MIL-D-70789A (AR)
AMENDMENT 2
09 November 1994
SUPERSEDING
AMENDMENT 1
14 April 1993

MILITARY SPECIFICATION

DYNAMIC REFERENCE UNIT (DRU)

Figure 11
ESS Temperature Cycle

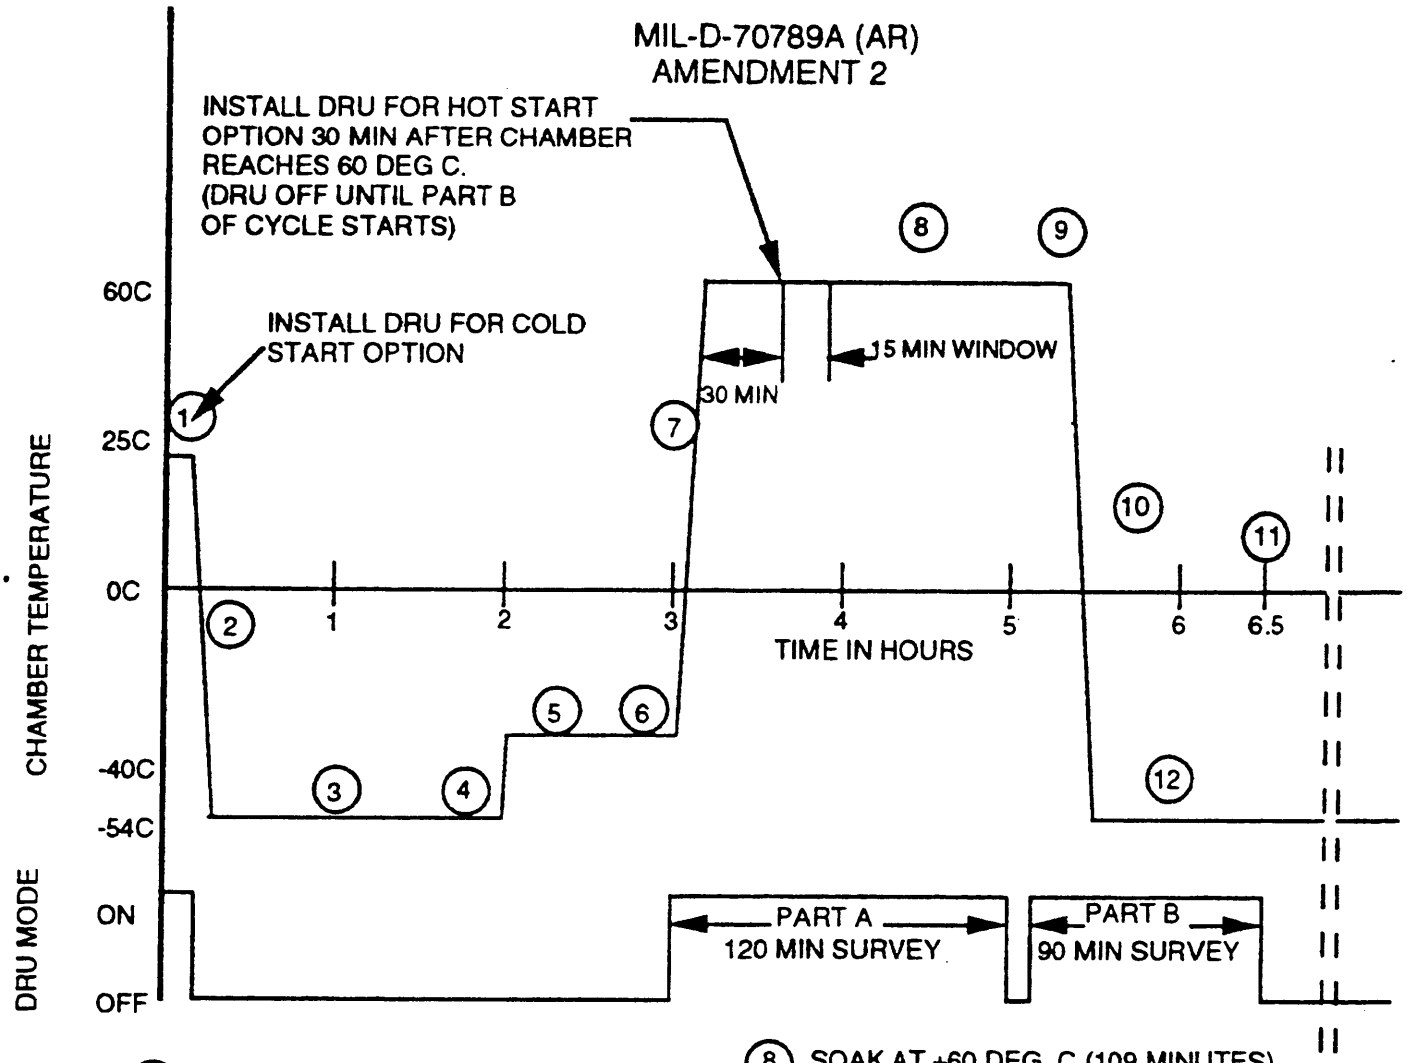
Figure 11, Temperature Cycling: Delete in its entirety and substitute as included page 67.
